ADDENDUM NO. 3

PROJECT NAME: **SAFD Warehouse Fire Protection Systems**

CIMS PROJECT NO.: **20-01050**

FIRE SPRINKLER PLANS, NOTES AND DETAILS

SHEET
FS1.1

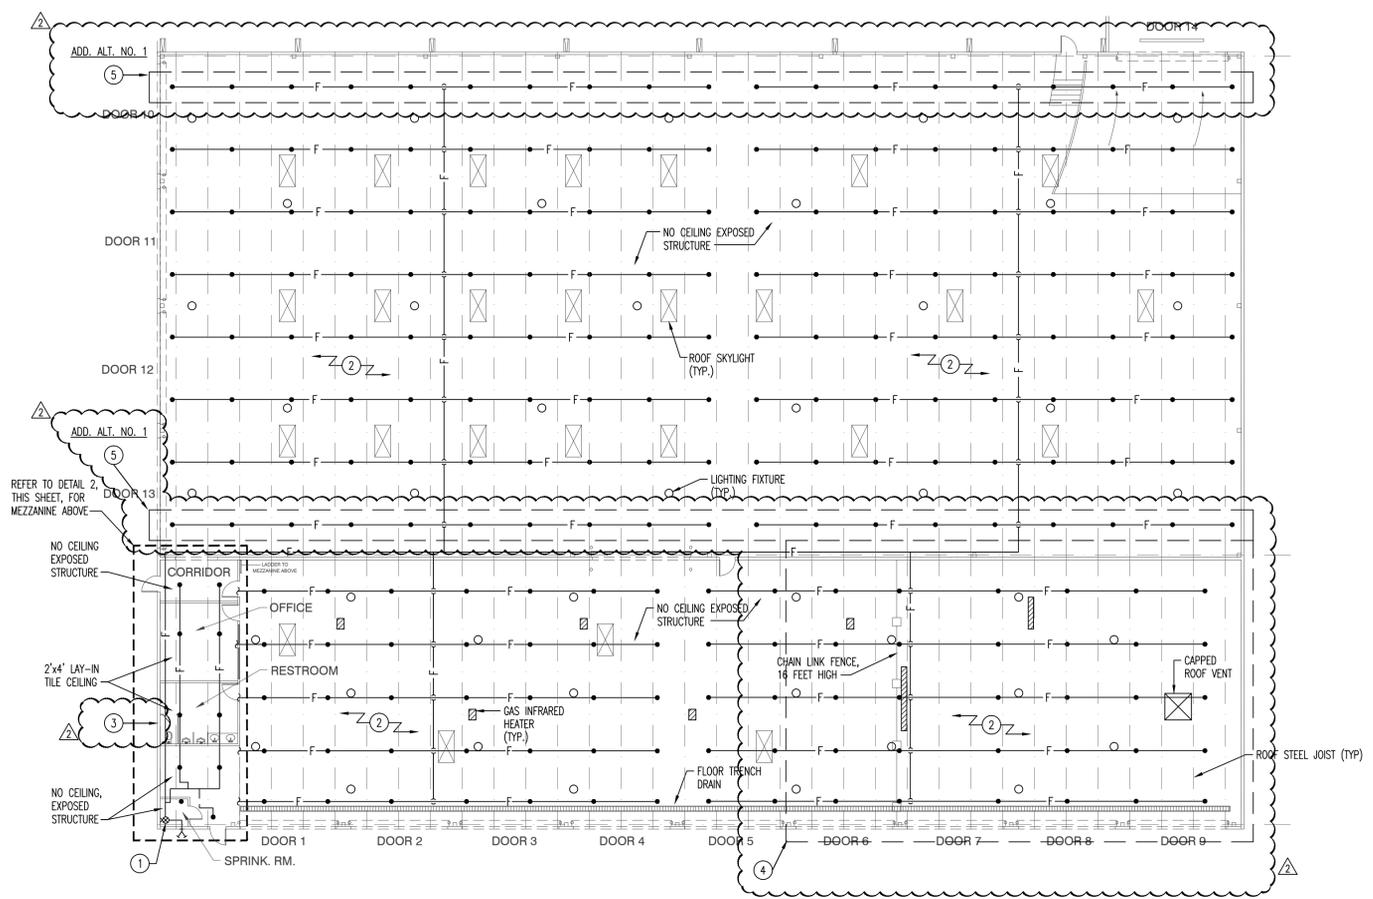
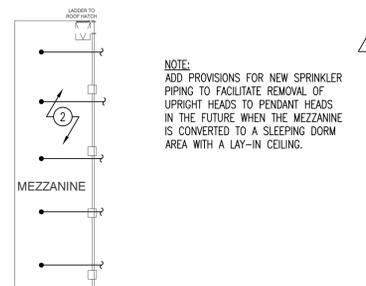
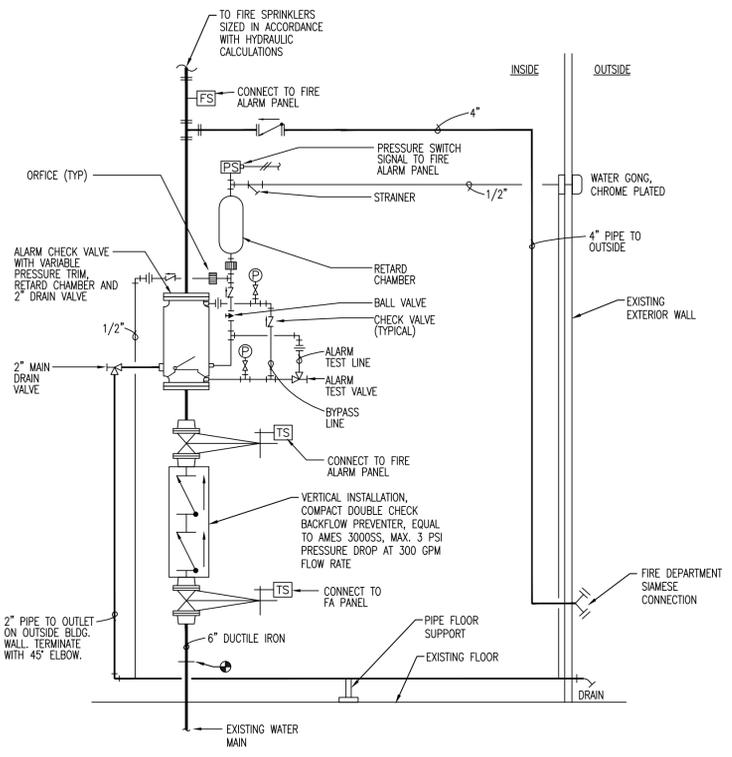
- Fire sprinkler hazard classifications are as noted on the attached drawing.
- Additive Bid Alternate No. 1 is as noted on the attached drawing.

- REMOVE FIRE SPRINKLER RISER AND ASSOCIATED CONTROL VALVE ASSEMBLY, DRAIN PIPING, AND FIRE DEPARTMENT CONNECTION.
- REMOVE FIRE SPRINKLER PIPING IN ITS ENTIRETY, INCLUDING ASSOCIATED SPRINKLER HEADS AND PIPE HANGERS/SUPPORTS. PIPING SHALL BE OWNER SALVAGE. CONTRACTOR SHALL LAY REMOVED PIPING OUTSIDE OF THE BUILDING WITHIN THE FENCED PARKING LOT, SUPPORTED OFF GRADE, IN A NEAT ORDERLY MANNER.
- SPRINKLER PROTECTION IN THE OFFICE, RESTROOM, AND AREAS UNDERNEATH THE MEZZANINE IS LIGHT HAZARD.
- SPRINKLER PROTECTION IN THIS AREA FOR HIGH-PILED STORAGE IN EXCESS OF 12 FEET IN HEIGHT, BUT NO LESS THAN 36" BETWEEN TOP OF STORAGE AND BOTTOM OF ROOF TRUSSES.
- ADDITIVE BID ALTERNATE NO. 1 - ADDITIONAL COST FOR CHANGING SPRINKLER PROTECTION IN THIS AREA (10 FEET OUT FROM WALL BY LENGTH OF WALL) FROM ORDINARY HAZARD GROUP 2 TO HIGH-PILED STORAGE.

- THE SPRINKLER PROTECTION FOR THE ENTIRE BUILDING SHALL BE ORDINARY HAZARD GROUP 2, EXCEPT FOR THE AREAS DENOTED BY KEYED NOTES 3 AND 4 ABOVE.
